To: Plan Holders for Improvements to the  
Washington County Airport  
Mineral Point, Missouri  
MoDOT Project No. 24-060A-1 & 24-060A-2

Transmitted herewith is **Addendum No. 1** to the Issued for Bid Contract Documents, Specifications and Plans dated May 28, 2024, for Improvements to the Washington County Airport.

**ADDENDUM NO. 1  
TO  
CONTRACT DOCUMENTS, SPECIFICATIONS AND PLANS  
FOR IMPROVEMENTS TO THE  
WASHINGTON COUNTY AIRPORT  
MINERAL POINT, MISSOURI  
MODOT PROJECT NO. 24-060A-1 & 24-060A-2**

DEMOLITION PLAN STA. 20+50 TO 24+50 RUNWAY 2/20		SHEET NAME C105
MoDOT PROJ. NO. 24-060A-1 & 24-060A-2	WOOLPERT PROJ. NO. 1015274	SHEET NO. 30 of 145

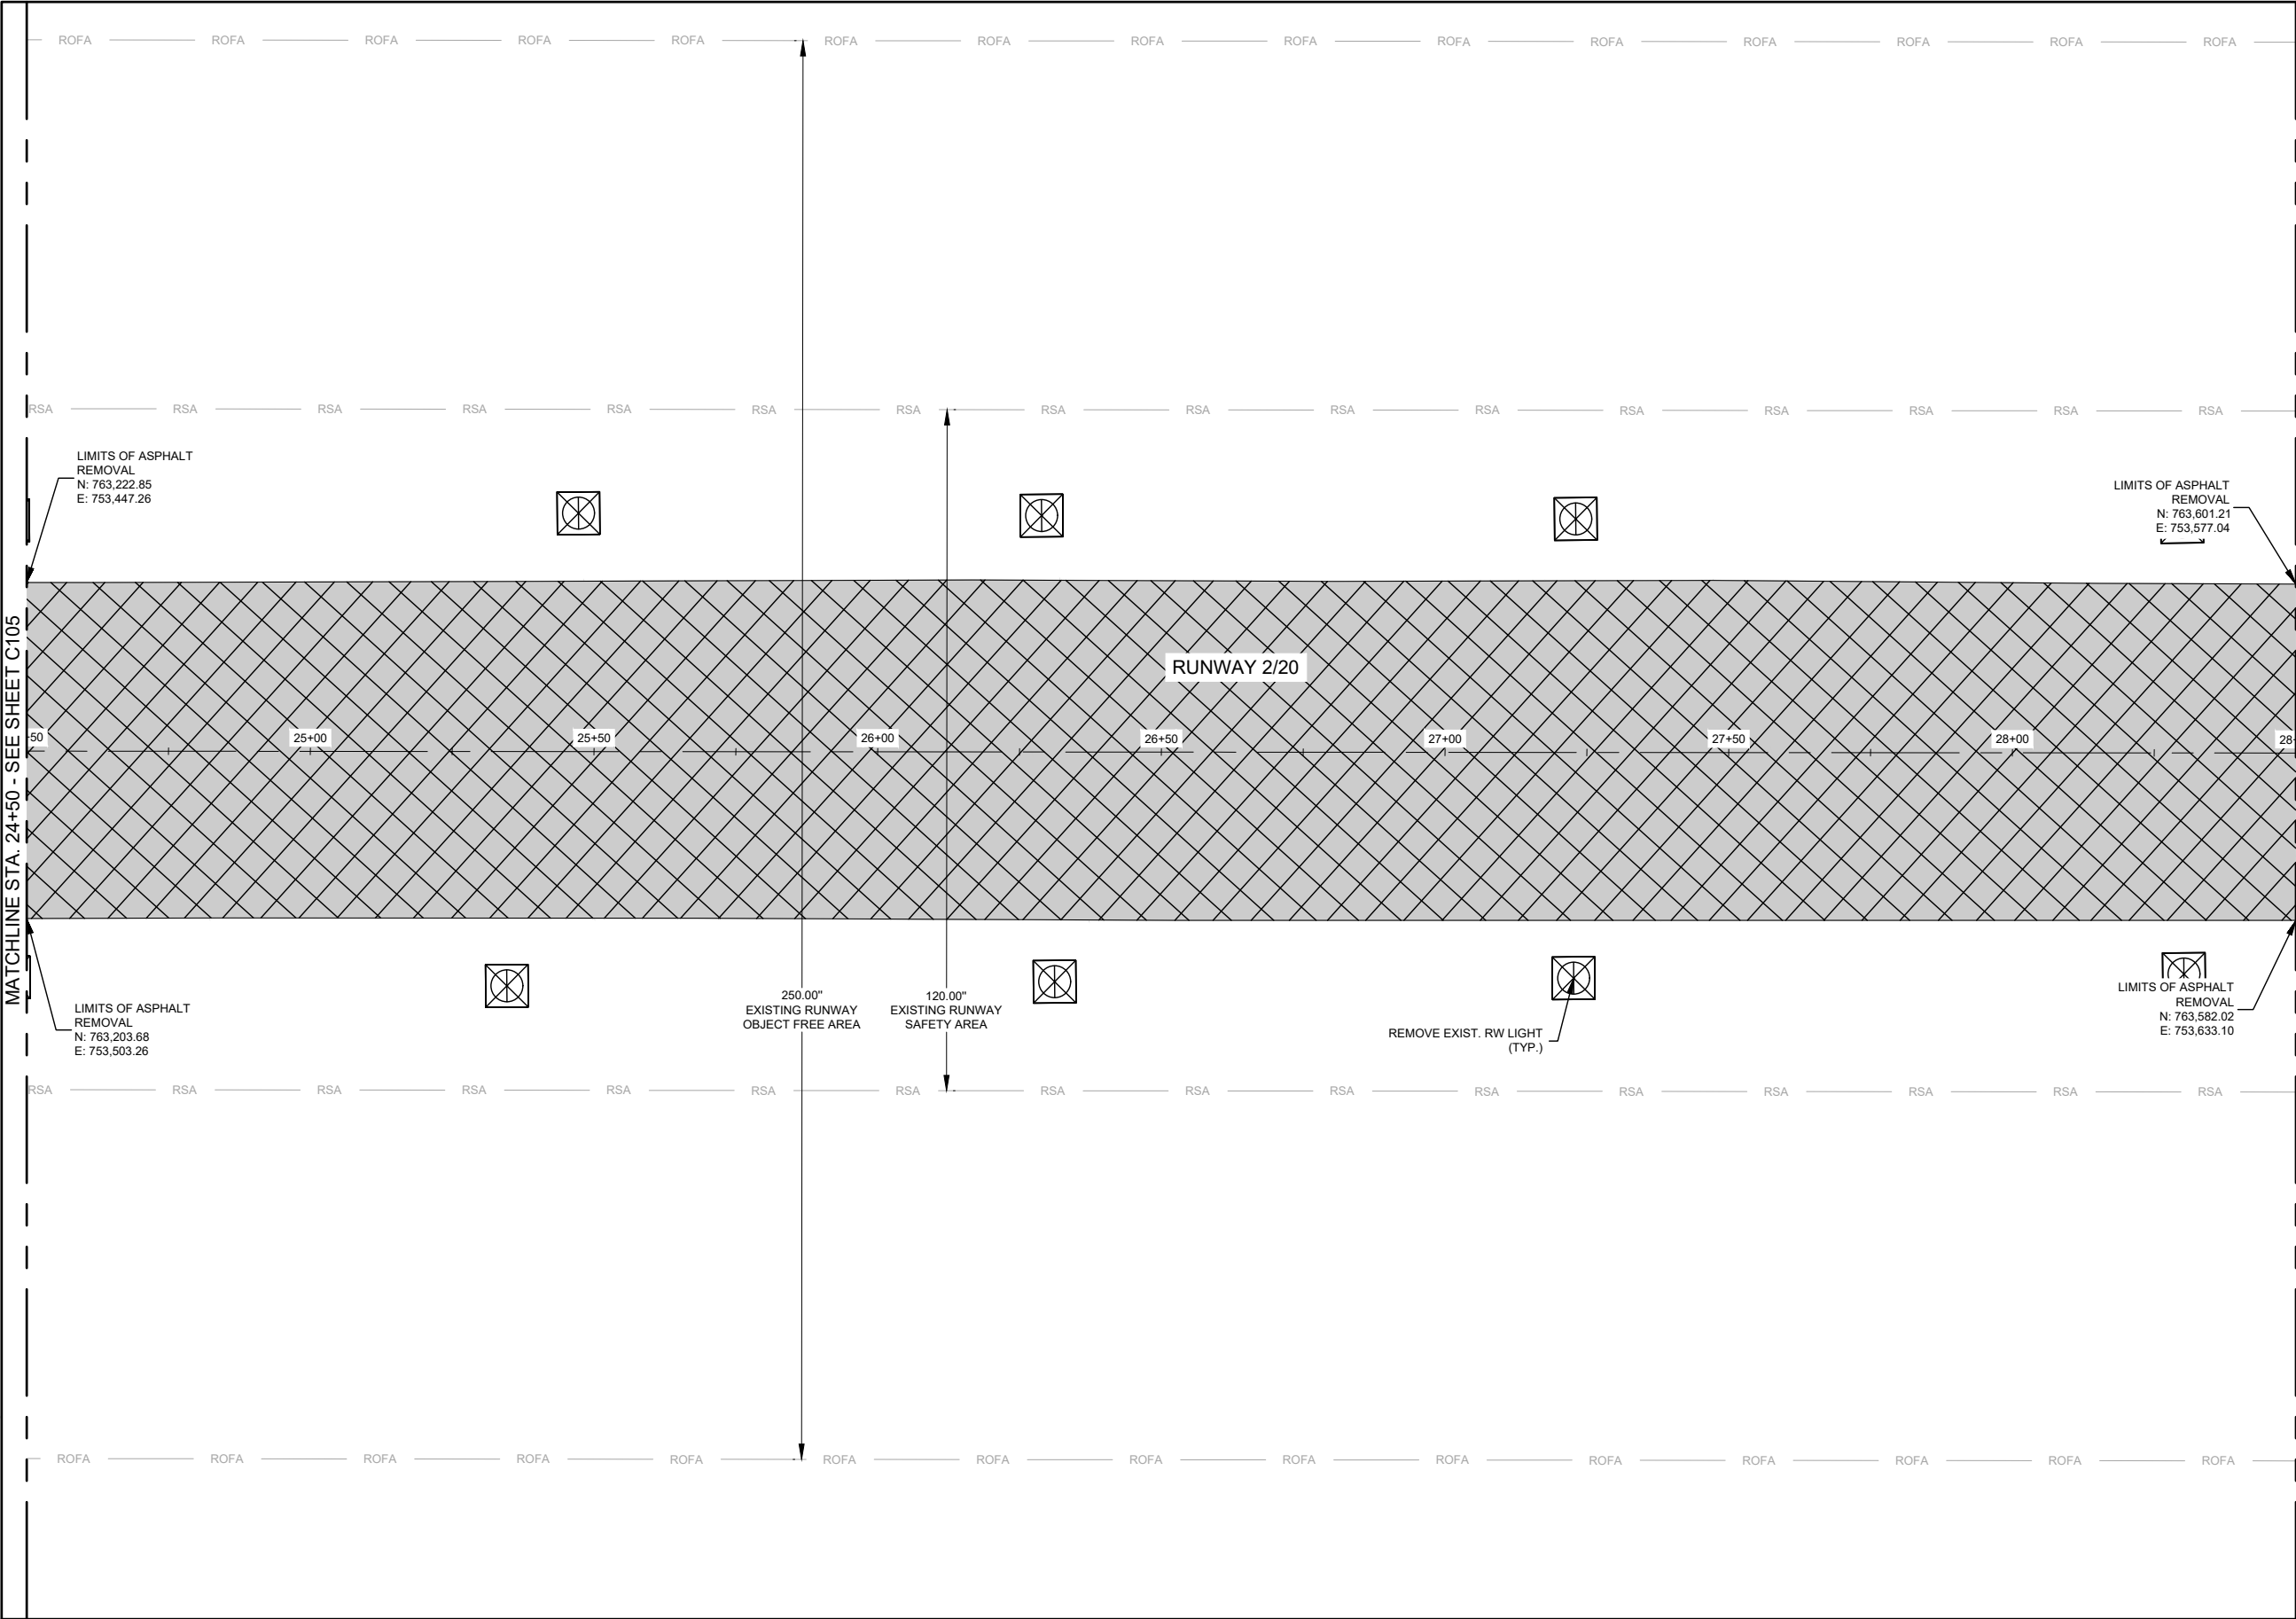
**Justification:** Updated the legend to include a 1.5" Nominal Depth for "Partial Depth Asphalt Removal" and remove the approximate depth from "Clearing and Grubbing".

SHEET NAME
C111
SHEET NO.
36 of 145

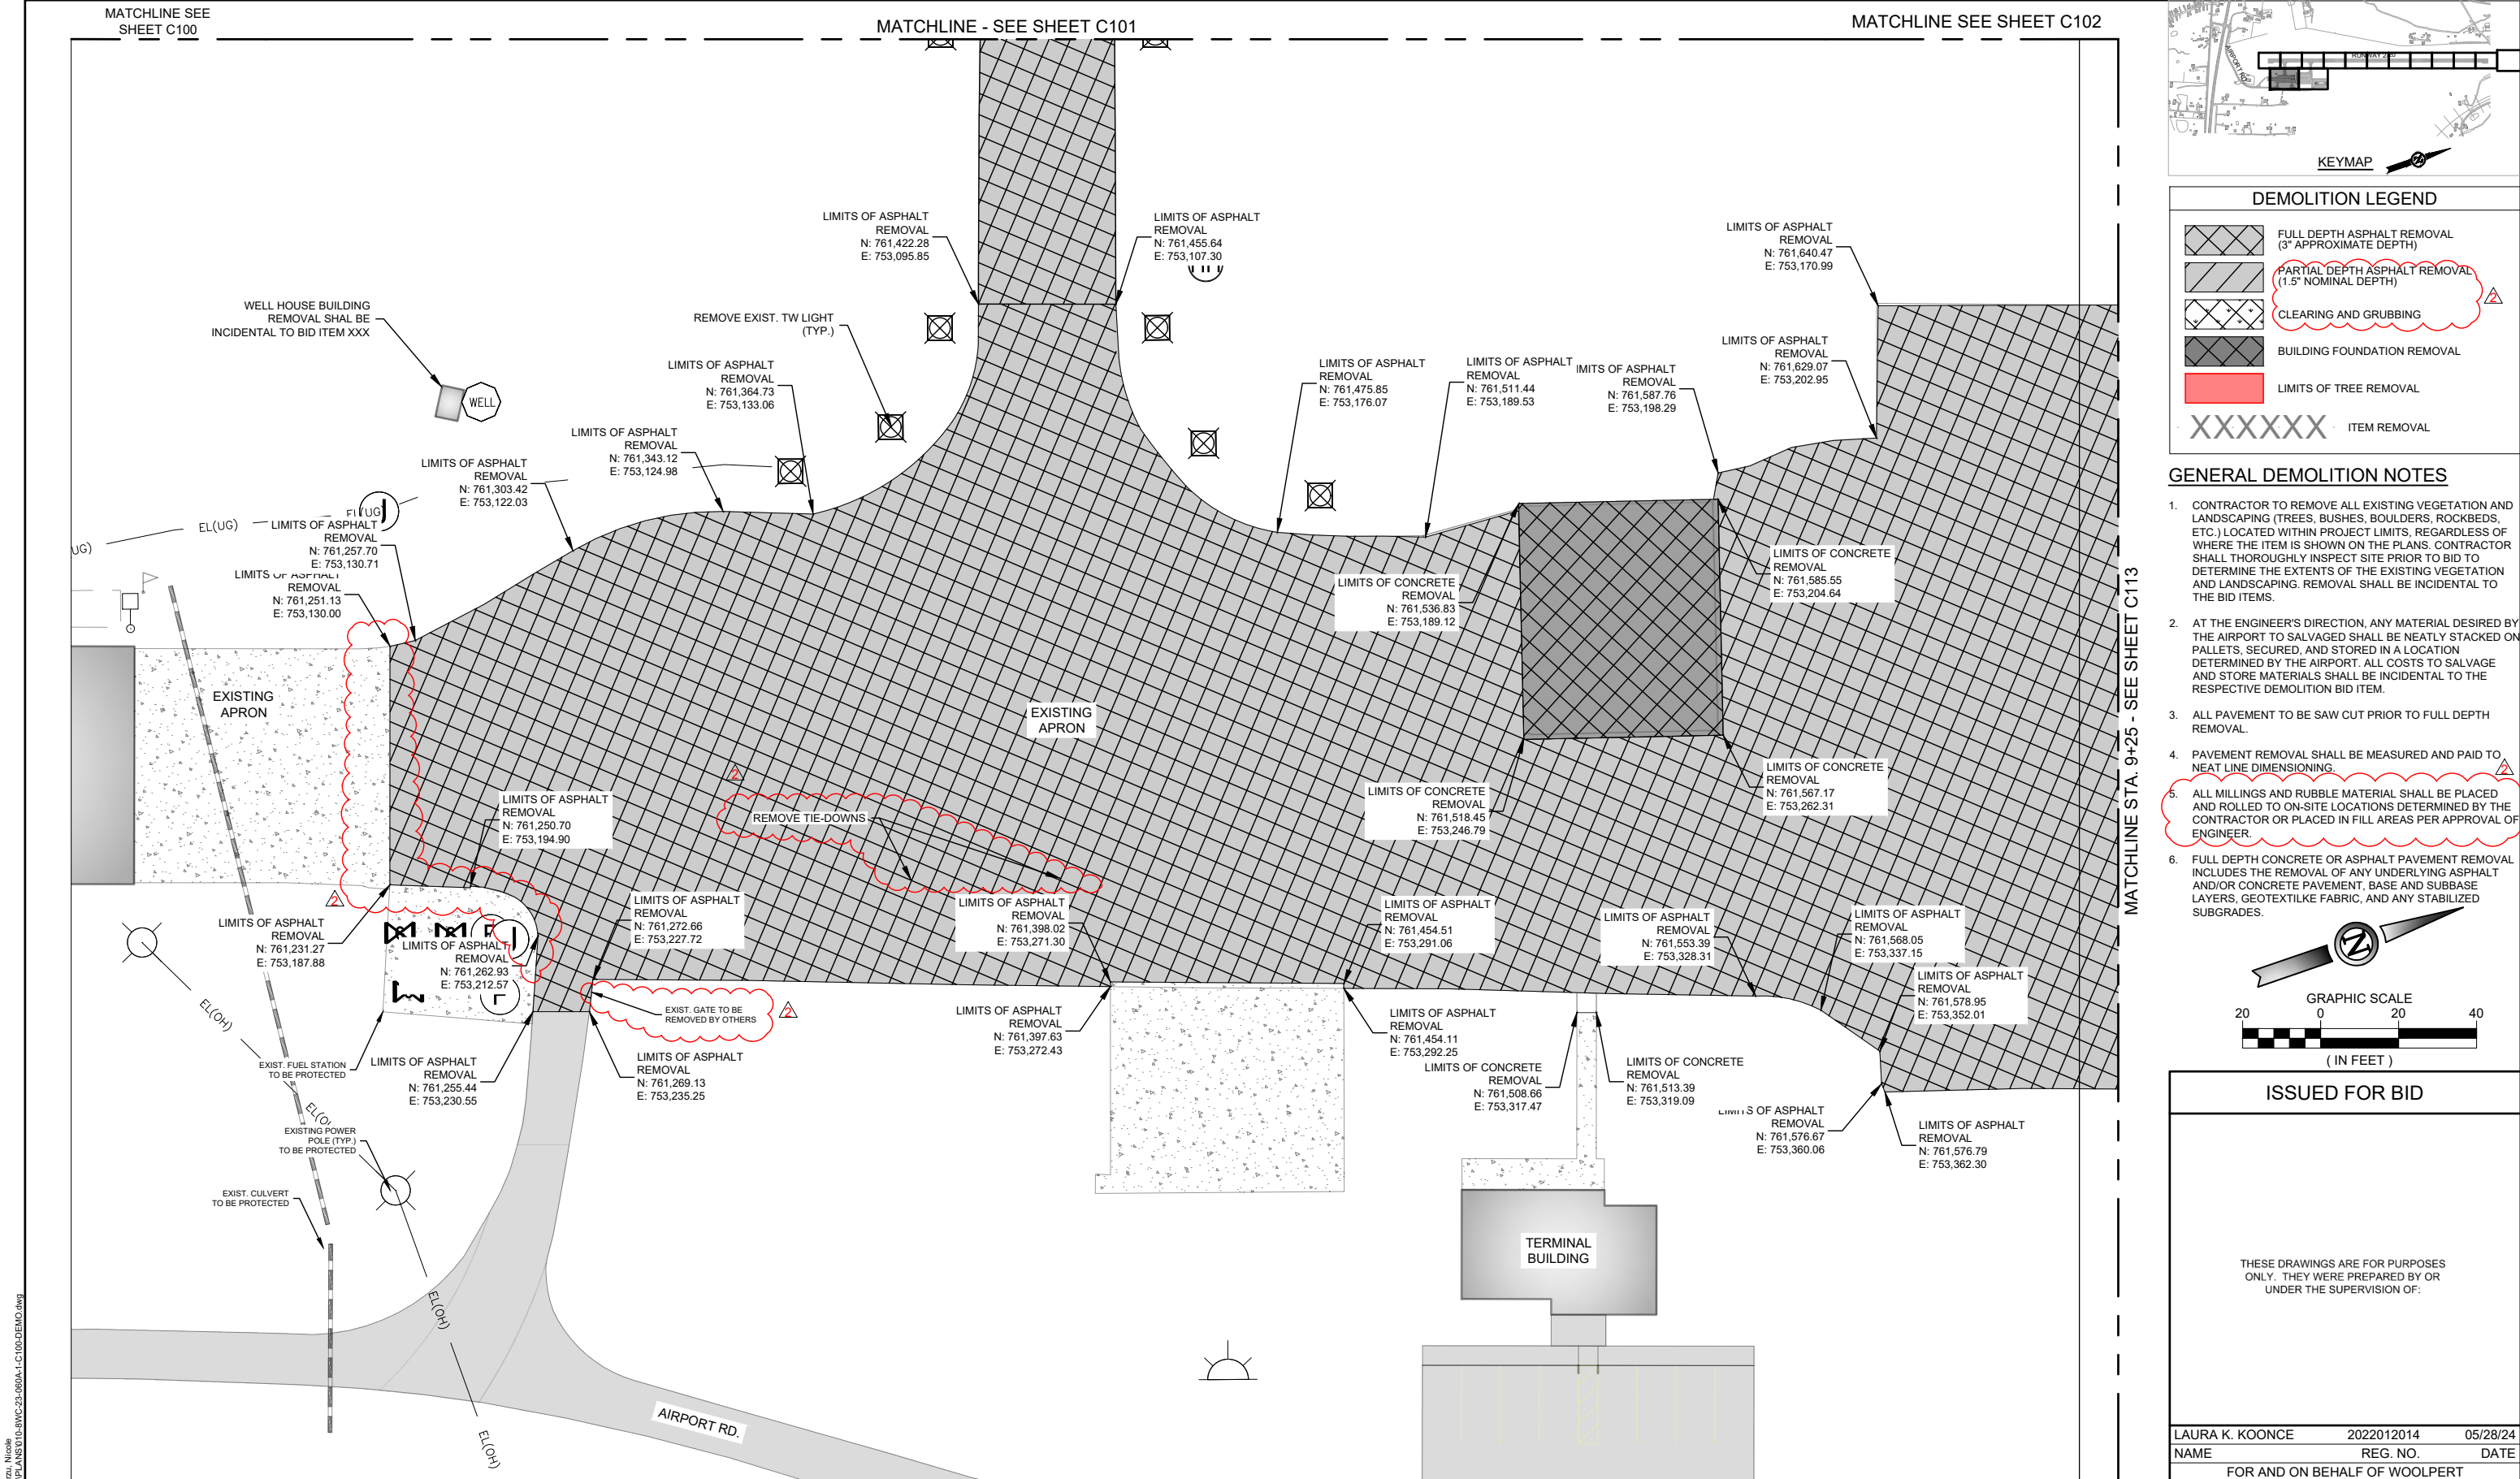
**Justification:** The fence removal limits were updated to match the revised fence geometry.

**Justification:** Updated the legend to include a 1.5" Nominal Depth for "Partial Depth Asphalt Removal" and remove the approximate depth from "Clearing and Grubbing".

GEOMETRY PLAN  
STA. 4+00 TO 9+25  
RUNWAY 2/20

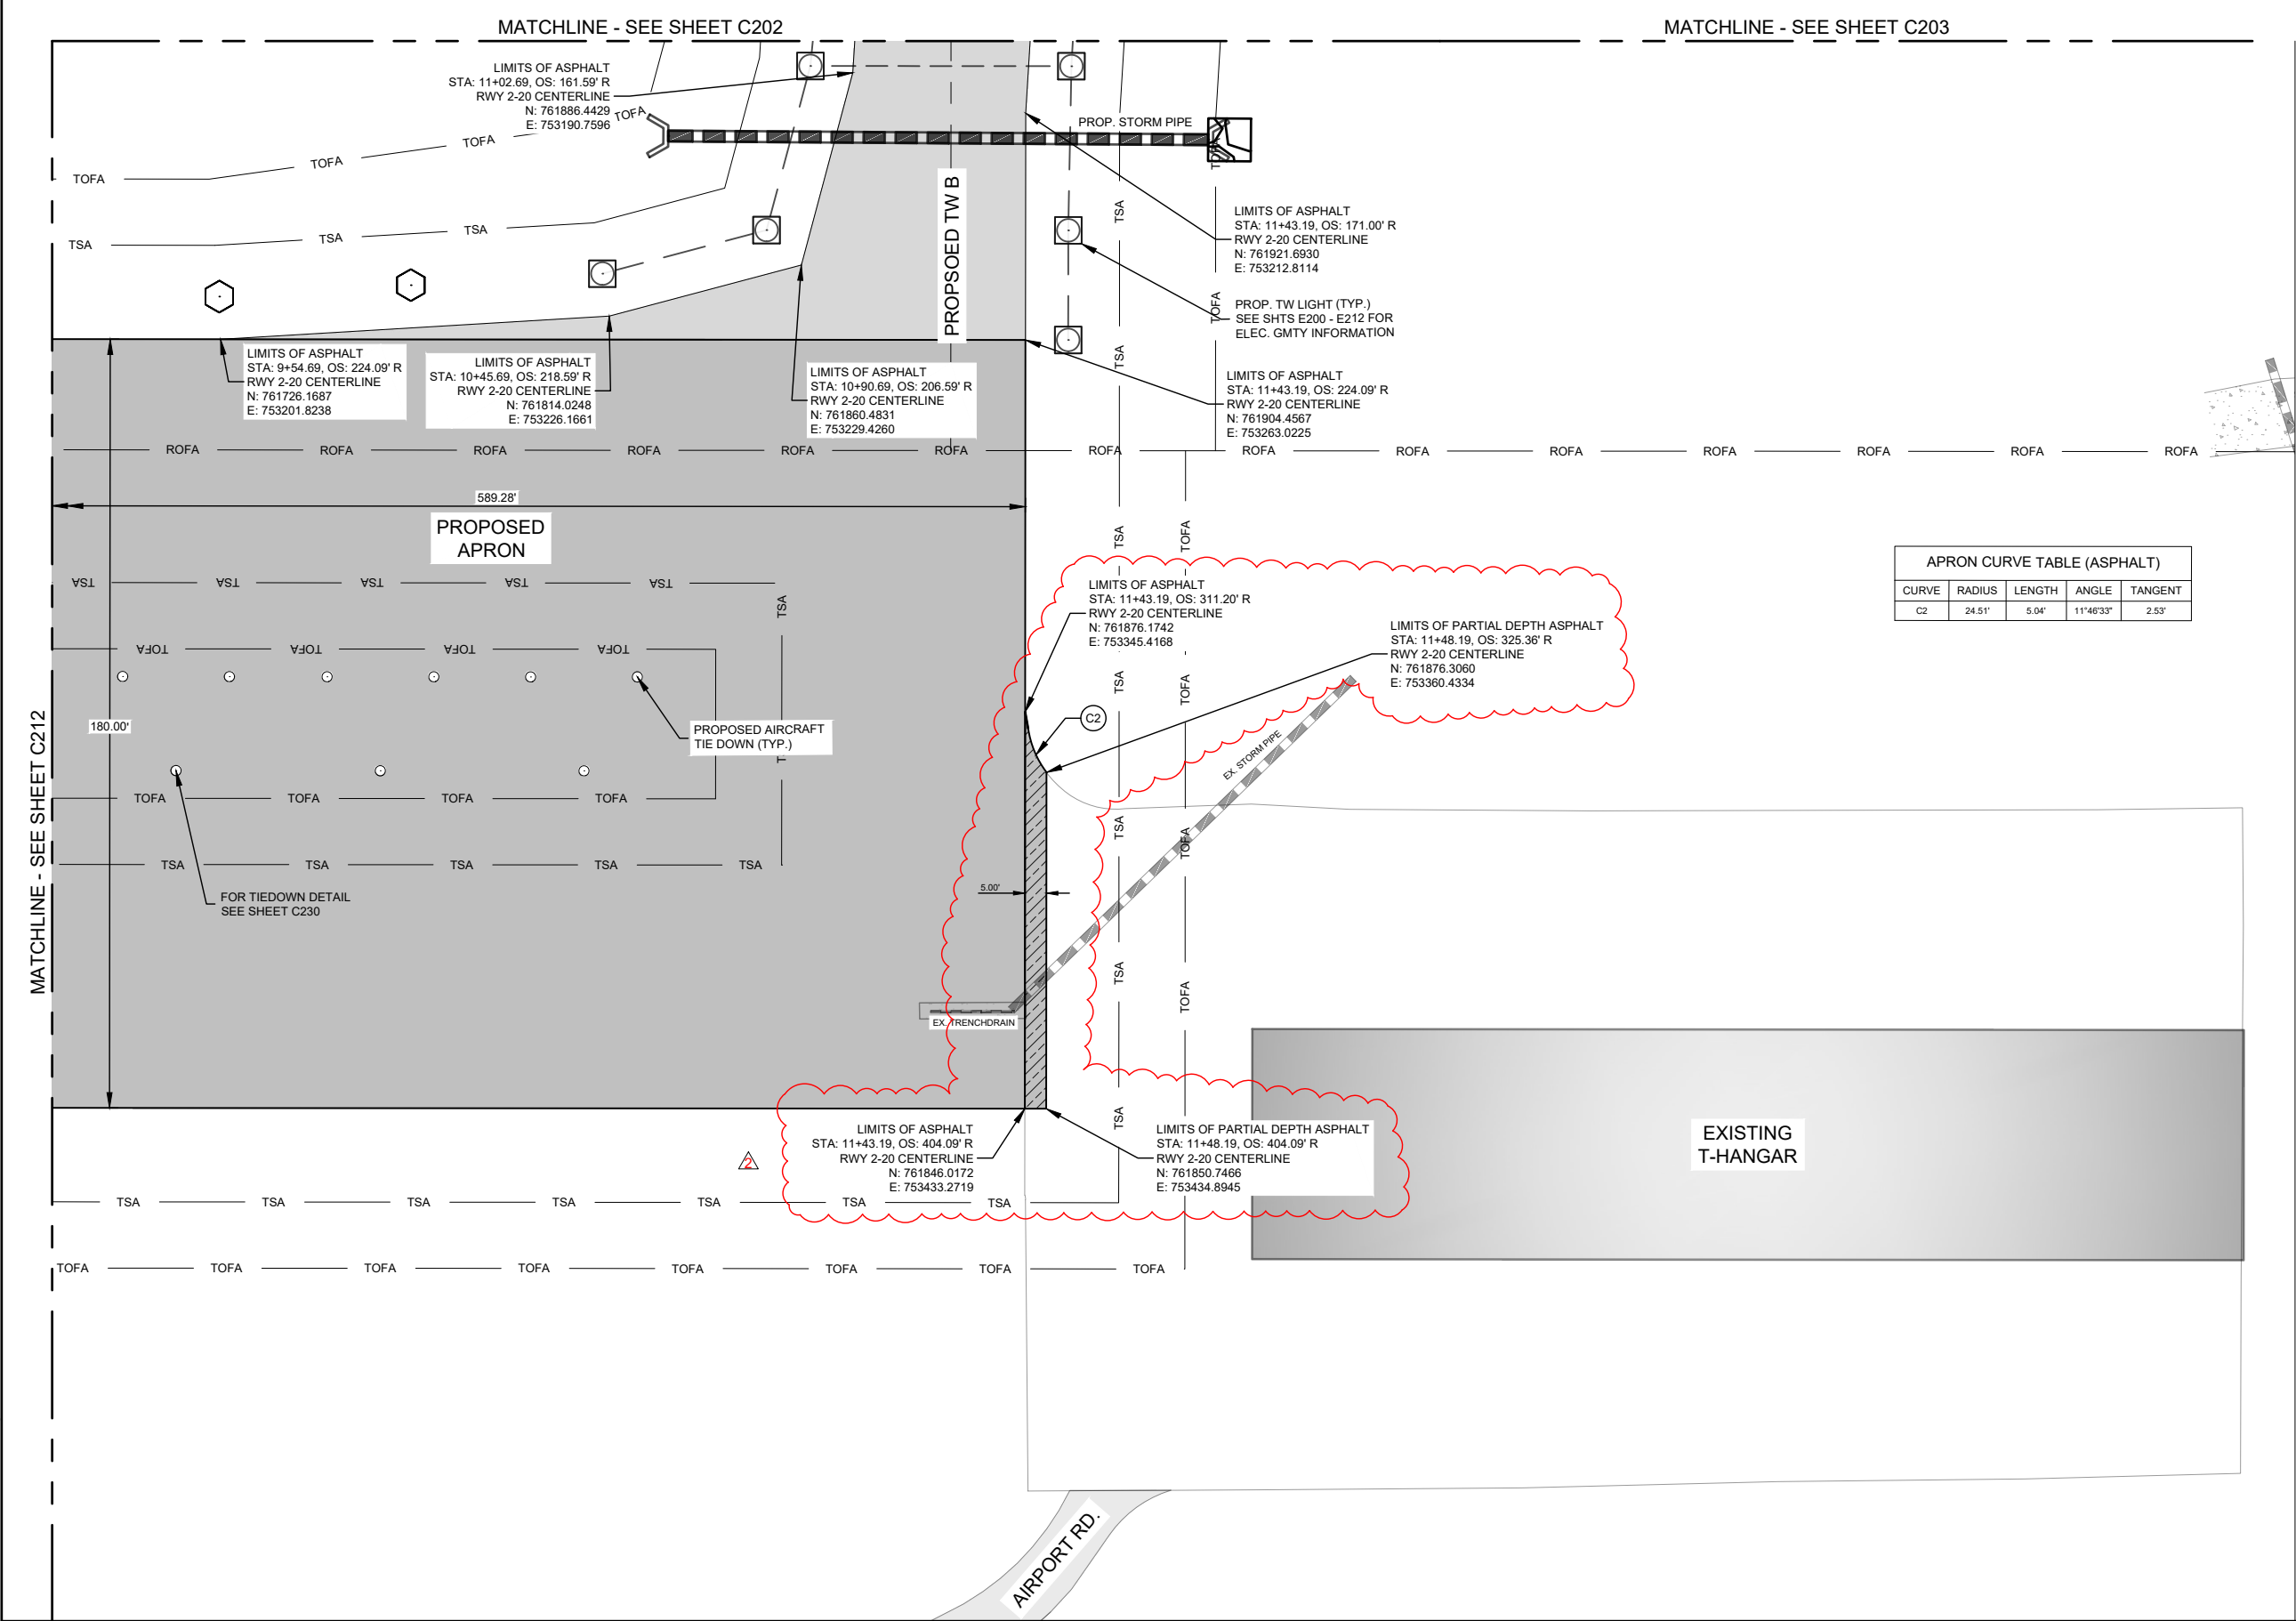
**Justification:** The south west corner of the apron geometry has been updated to provide easier access and to meet design safety requirements.
